Cedron Heights

ref: Cedron Heights Subdivision

Re: Workplan to address concerns outlined in DEQ letter of August 18, 2009 regarding DEQ review of Cedron Heights Subdivision Level 1NP Study, Victor, Idaho.

enclosures: Figure 1. Site Sampling Location Map

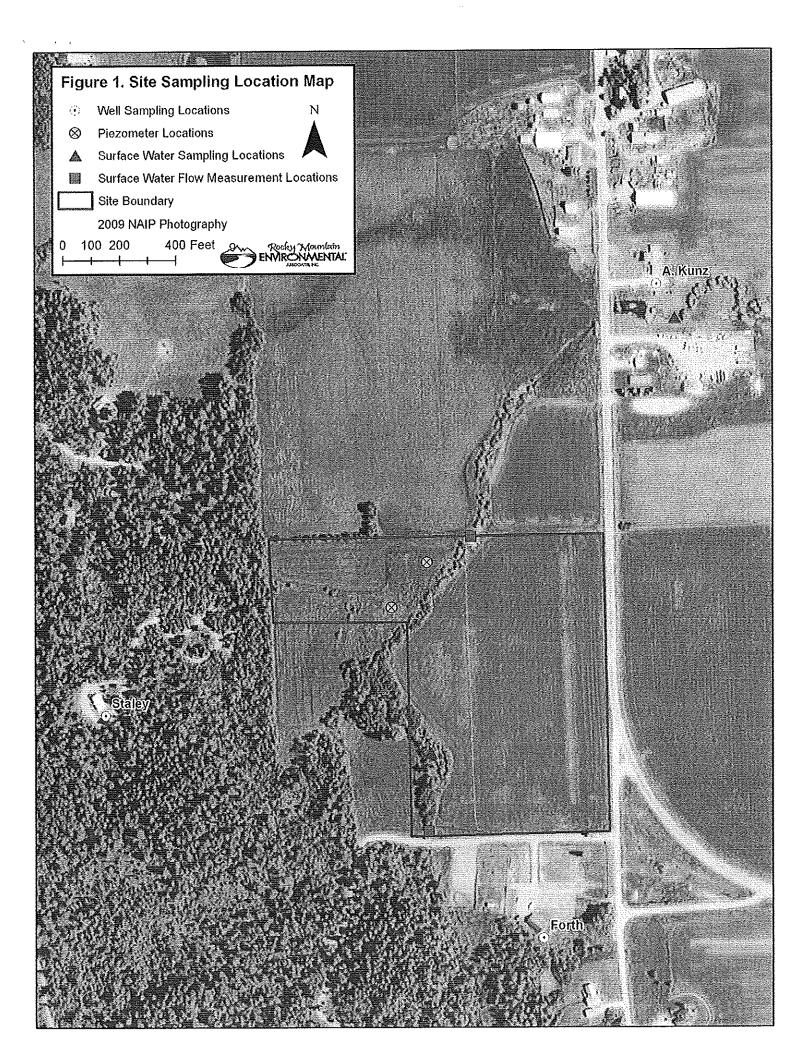
- 2. Some comments on and adjustments in the WQ sampling program I would suggest are (a) collocate the SW sampling onsite with the flow measurement locations; this may entail adding a SW sampling location to the program (b) add a Creek sampling location to the west on the other side of the road from the Kunz household location and finetune the sampling done in the Kunz household area (c) given comments below regarding the "uppermost gw" that should be the goal of the impact analysis the sampling program in the area of the GW discharge here should be clarified (d) how recent are the Teton River WQ measurements and where specifically are the sampling locations in relation to the site? and (e) we might not need to sample all the GW wells given comments below regarding the GW system they represent.

- 5. More detail is needed on piezometer construction. How frequently will these piezometers be measured and when will flow measurements be made? Are these fields typically irrigated during the growing season?
- 6. This is covered by my comments above.
- 7. Defer to you.
- 8. Defer to you.

RMEA proposes two forms of investigation to address this concern. First, we will attempt to install two monitoring wells (piezometers) on the west side of the creek using hand augering equipment (Figure 1). The wells will be completed to a depth below the adjacent channel elevation of the creek, and will be checked from the presence of water a minimum of one week following installation. We will also log the shallow soil conditions encountered in each boring. Second, we will perform a surface water flow measurement in the creek where it enters the site on the south side, and at the northern site boundary where the stream exits the property. This will be done to determine if there is a gross loss of flow in the stream as it crosses the property, indicating a losing condition.

Figure 2. Groundwater Elevation Map

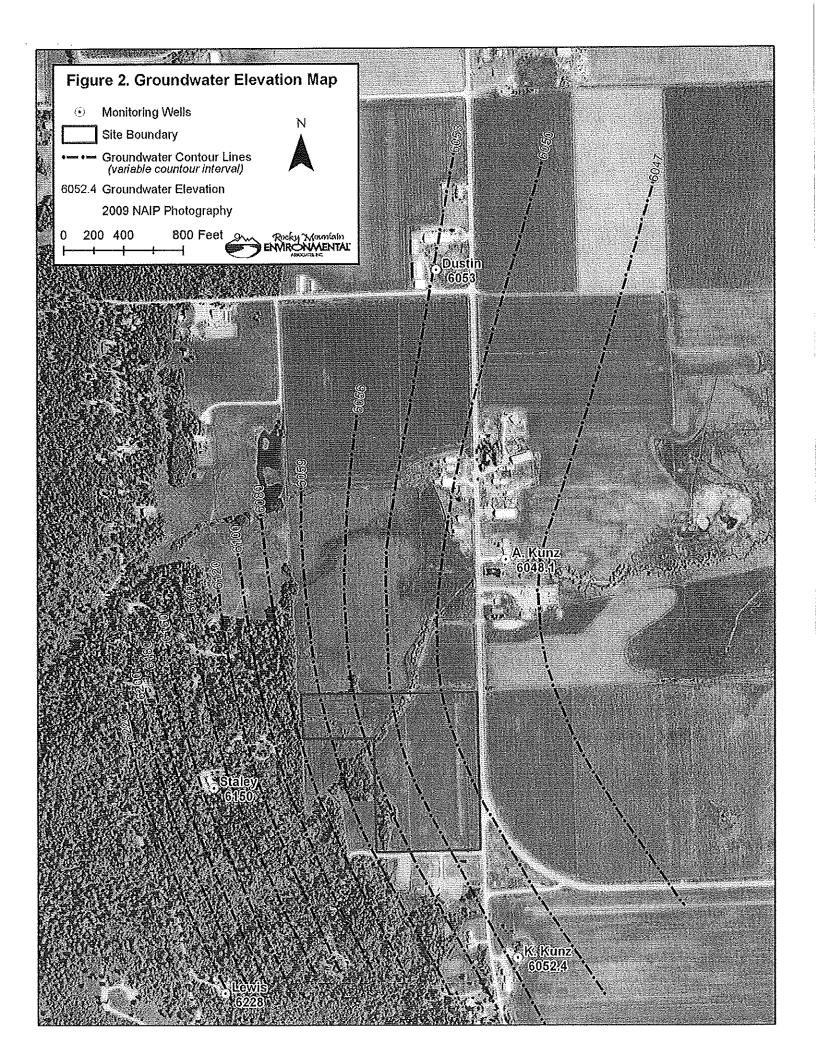
- 3. The measurements and logic behind the groundwater direction and gradient proposed seem reasonable. It would be helpful to know the construction of the wells being used to construct the potentiometric surface map. Also, given the acknowledged presence of very shallow GW and a GW discharge zone on the east side of Cedron Rd. does this potentiometric map represent deeper GW that would likely not be impacted by onsite systems? What is the source of the GW discharging here and what is its relationship to the GW system measured in the wells? It may be helpful to include a flow measurement in the area of GW discharge east of Cedron Rd., if this water is water potentially impacted by the development.

is slightly greater on the west side of the site, and slightly lower on the east side. Our map places the 6050 groundwater elevation contour in essentially the same position as depicted by Kilburn (1964).
